Office of the Health Officer

DATE: March 27, 2014

RE: **Building Permit # B14000696**
14914 Victory Lane
Glenelg, Maryland 21737

PLOT PLAN FOR BAT INSTALLATION

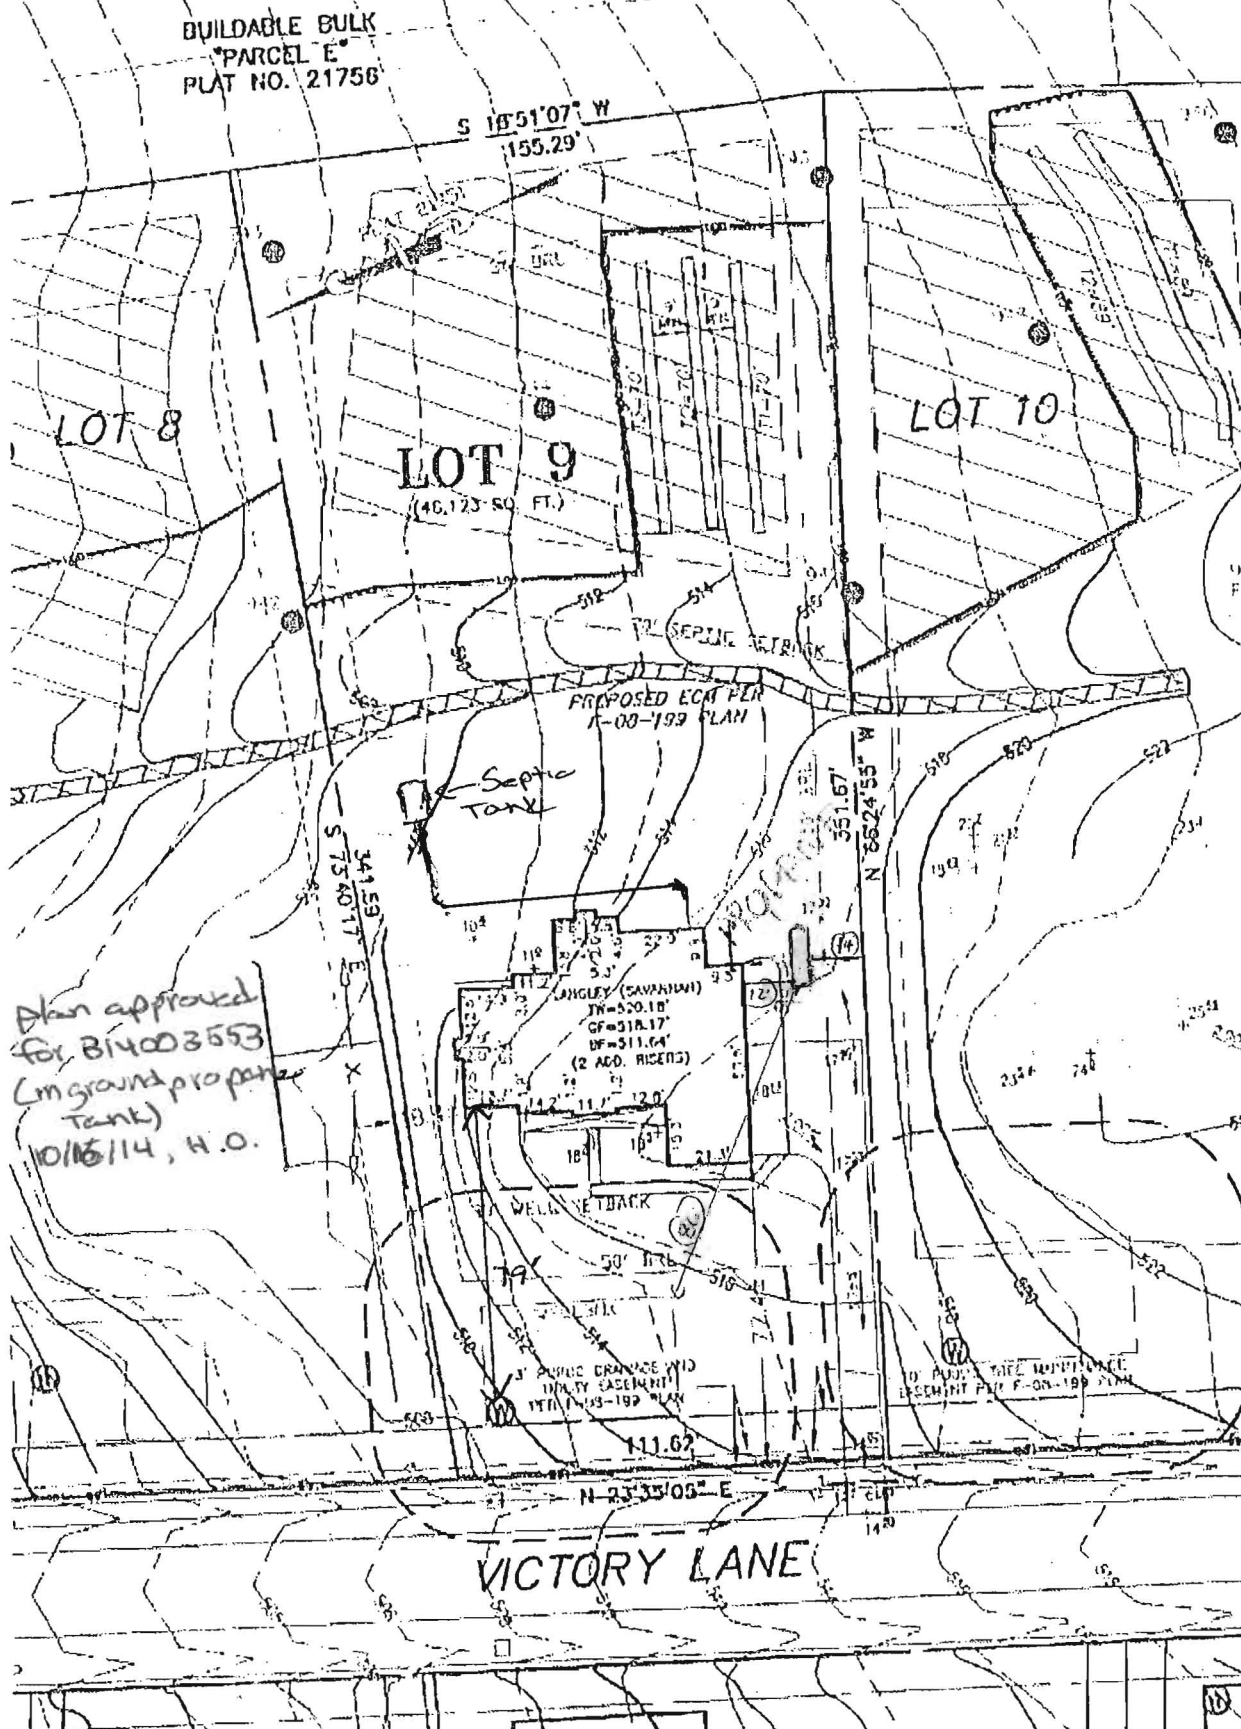
Further review is contingent upon submission of a revised building plan showing the following:

- As of January 1, 2013, all new construction is required to use the "Best Available Technology" (BAT) for septic installation. Before building permit approval, a **BAT** site plan must be submitted along with your building application and building plan.
- Floor plans for the proposed house must be submitted.

I have reviewed your plans and there are a few revisions needed. The tank must be 10 feet away from the lot lines. And the floor plans have revealed 5 bedrooms instead of 4, so your calculations on the BAT plan and Building plan must reflect 5 bedrooms. Please make sure during your revisions you change the amount of trench needed , it should reflect your new calculations. If you have any questions don't hesitate to give me a call.
